WCAP-16793-NP, Rev.0 (Non-Proprietary)
Project No. 694

March 2, 2009

OG-09-84

Subject: Pressurized Water Reactor Owners Group
Responses to the NRC Request for Additional Information (RAI) on WCAP-16793-NP, "Evaluation of Long-Term Cooling Considering Particulate, Fibrous and Chemical Debris in the Recirculating Fluid" (PA-SEE-0312)

Figure 28: Core Pressure Drop for Uniform $C_D = 100,000$ Case

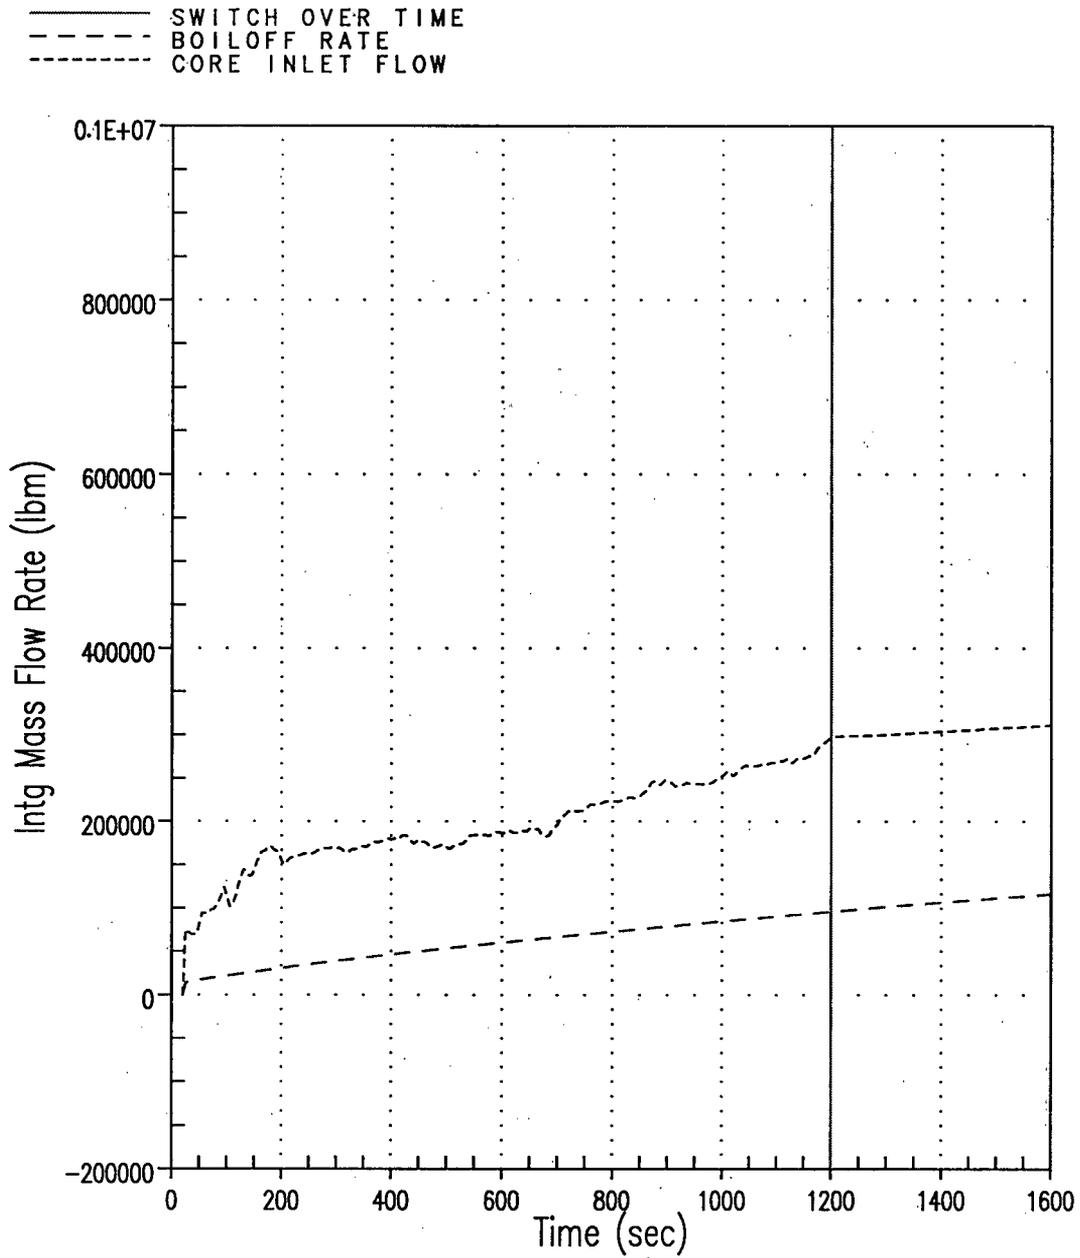
- 1) WCAP-16793-NP, Appendix B, presents analyses of the effect of core inlet blockage using the WCOBRA/TRAC analysis code. Since the report was prepared additional analyses have been performed to determine the blockage level that would reduce core flow below that necessary to match coolant boil-off. Please provide documentation of the additional analyses that have been performed, including figures, for the integrated core inlet and exit flow, peak cladding temperature, core collapsed liquid level, core exit void fraction, and core pressure drop for the bounding conditions. The results should be presented for each case analyzed up to and including the blockage level for which boiloff is no longer satisfied.

The second uniform loss coefficient run performed applied a uniform C_D of 100,000 at the core inlet. The requested plots for this case are shown in Figures 22 through 28. Figures 22 and 23 show comparisons of the integrated core inlet flow and boil-off rate. As shown, even with the further increase of the loss coefficient at the inlet, the flow that enters the core is still in excess of the boil-off rate. (Note that the integrated mass flow rate of Figure 23 shows a similar behavior as was shown in Figure 16. Again, this is due to the 30 second ramp-up of the hydraulic loss coefficient, C_D , to 100,000 that is initiated in the calculations at time $t = 1200$ seconds, but extends the behavior over a slightly longer period of time.) Figure 24 displays the integrated liquid flow at the core exit. The figure displays that liquid in excess of that needed to keep the core quenched enters the core and that some liquid flow is still present at the top of the core even after the increase of the loss coefficient at the inlet. The PCT is shown in Figure 25. There are no significant PCT excursions after the core inlet loss coefficient is increased. Figure 26 displays the collapsed liquid level of the average assembly core channel (Channel 11 of Figure 6.3.4-3 in Reference 1). The figure shows that the collapsed liquid level drops slightly at time blockage occurs, however, the liquid level recovers even after the increase in the loss coefficient at the inlet. The void fraction at the core exit shown in Figure 27 again illustrates that liquid is present at the top of the core which shows the flow that enters the core after the increase of the loss coefficient occurs is still in excess of the boil-off rate. The core pressure drop is displayed in Figure 28. The figure displays an increased pressure drop of roughly 2 psi as blockage at the core inlet is increased. As the conditions in the Reactor

Figure 1: Survey Results of PWR Sump Screen Fibrous Debris Bypass

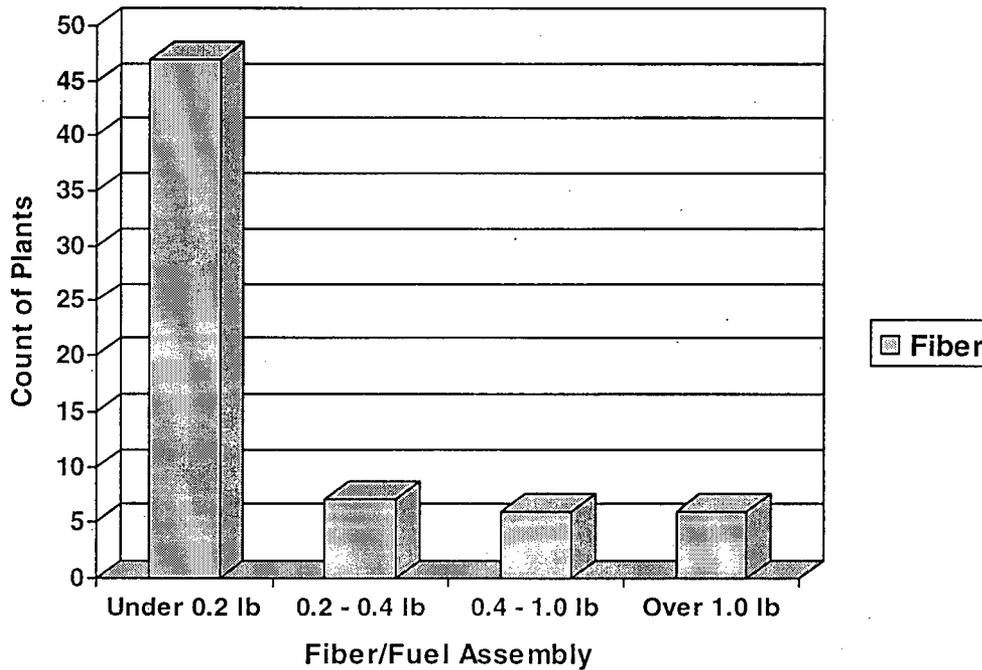
- 5) Please provide data that show the basis for the assumption that fibrous strainer bypass of 1 ft³/1000 ft² of strainer area provides a reasonable estimation of fiber bypass and that use of this number will not affect plant evaluations non-conservatively. Note that some protective fuel filters may be challenged by lower amounts of fiber (i.e. a thin bed) while some may be challenged by higher amounts. Please verify that these data were correlated with the area of the test strainer and that the results were not confounded by extrapolation to strainer areas less than the total of all strainers that may be in service during the event (i.e., strainer bypass estimates should assume all available strainer area is available for bypass).

The assumption of fibrous strainer bypass of 1 ft³/1000 ft² of strainer area has been replaced by considering sump screen fiber bypass mass on a per fuel assembly basis. Total sump screen fiber bypass mass has been provided by licensees through a PWR Industry survey. This licensee-provided information was used to determine the amount of fibrous debris used in fuel assembly debris capture testing. The following chart shows the breakdown of bypass fibrous debris on a per fuel assembly basis for all plants that participated in the survey. The figure takes into account the number of fuel assemblies in the core of each plant reporting sump screen bypass values.

Figure 1: Photograph of the Westinghouse Fuel Test Vessel

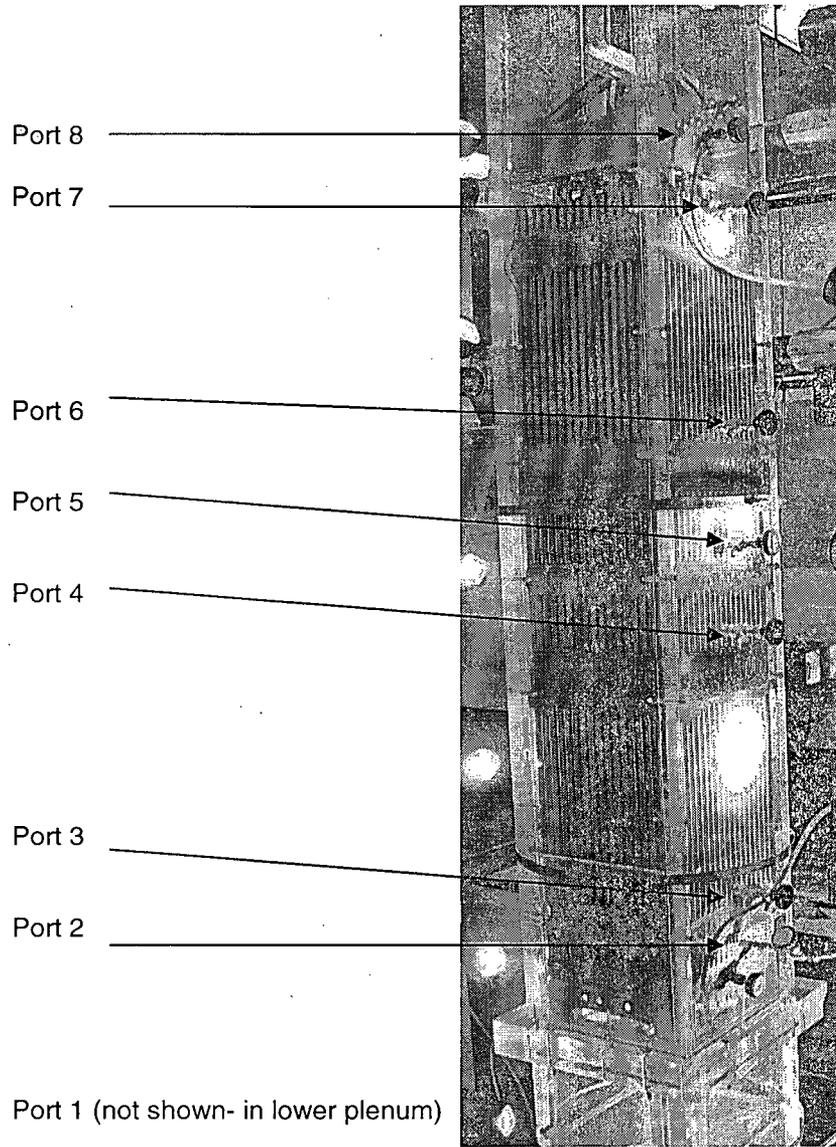
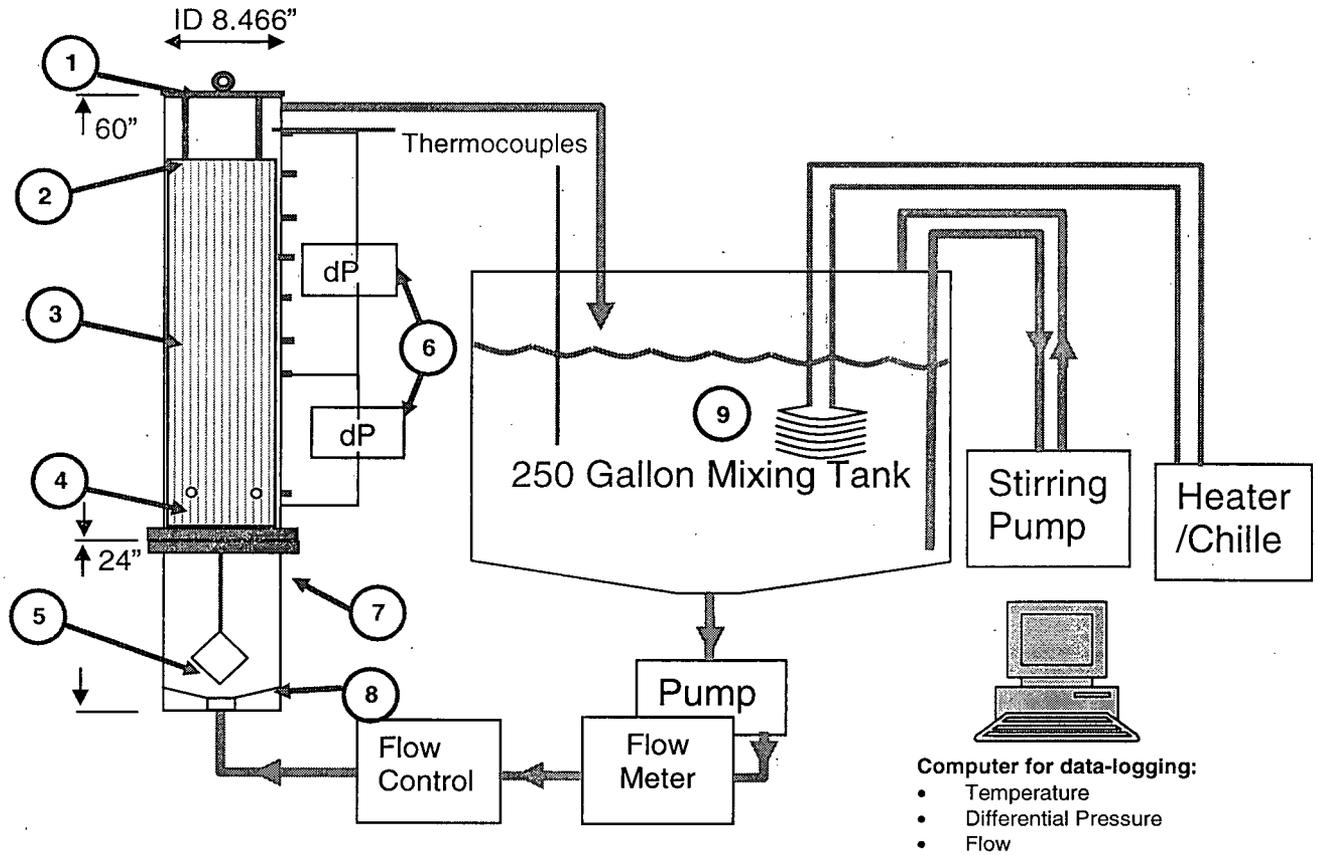
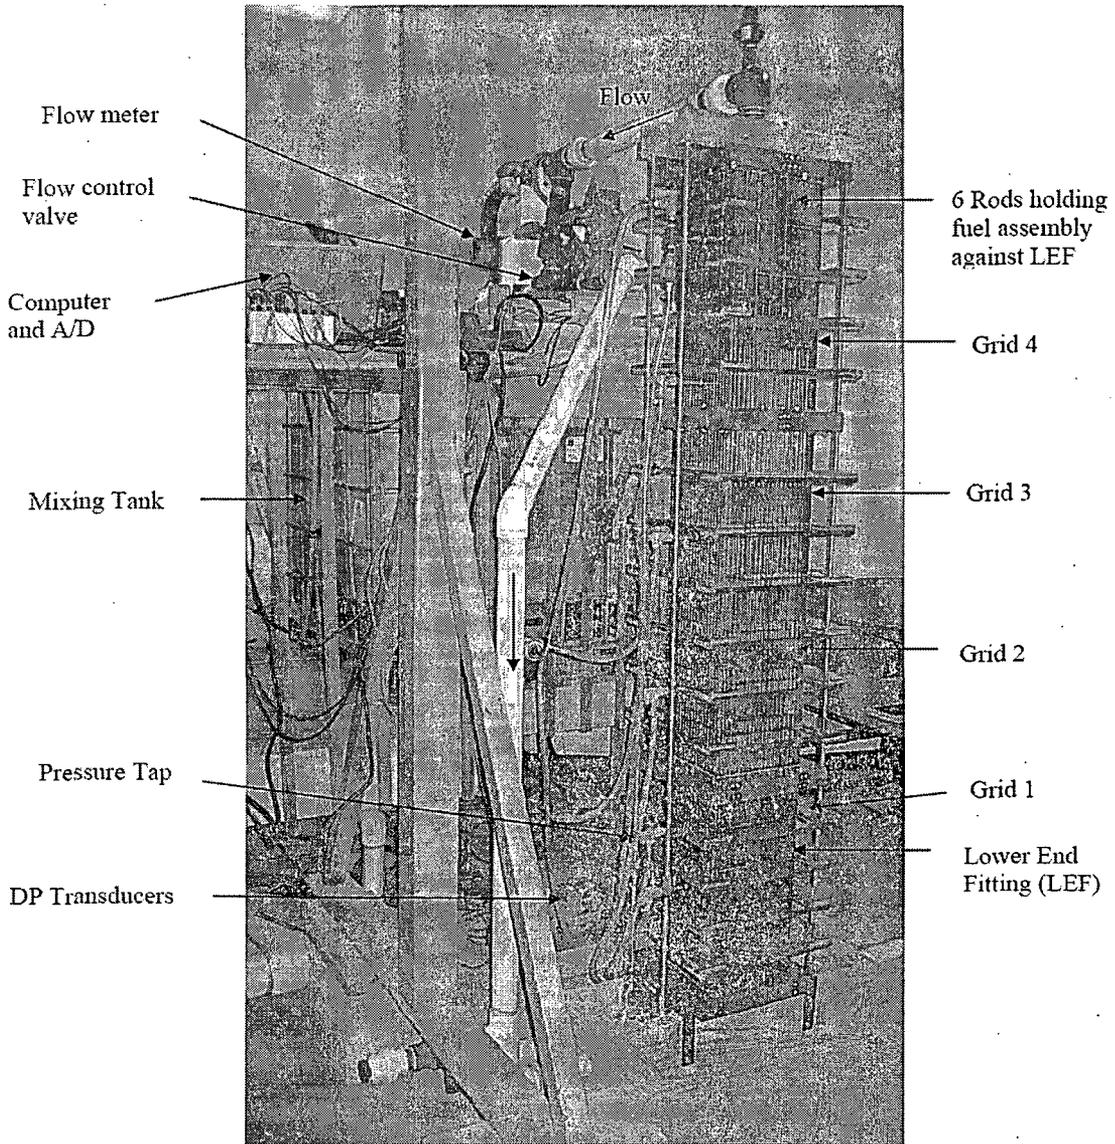
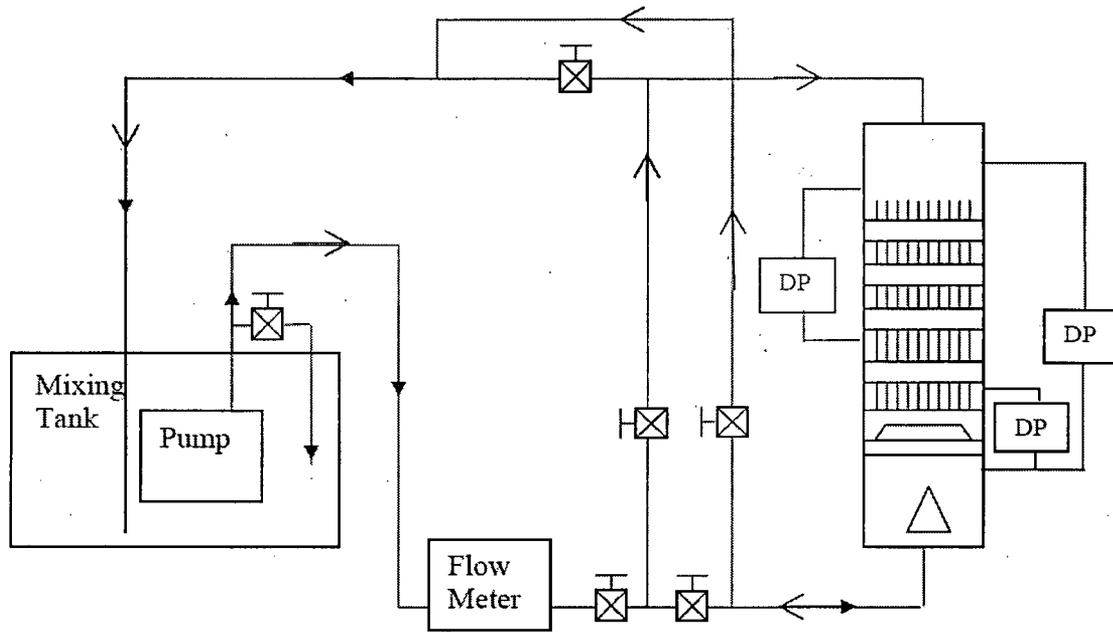
- 6) Please provide the following information for all fuel/core blockage tests that have been sponsored by the PWROG.
- a. flow rates and bases including any variation in the flow rate during testing

The Westinghouse test loop for testing the debris capture characteristics of a full-width fuel assembly is shown in Figure 1. A schematic of this test loop is given in Figure 2. The AREVA test loop is shown in Figure 3. The schematic of this test loop is shown in Figure 4. The test loop is composed of four main parts:
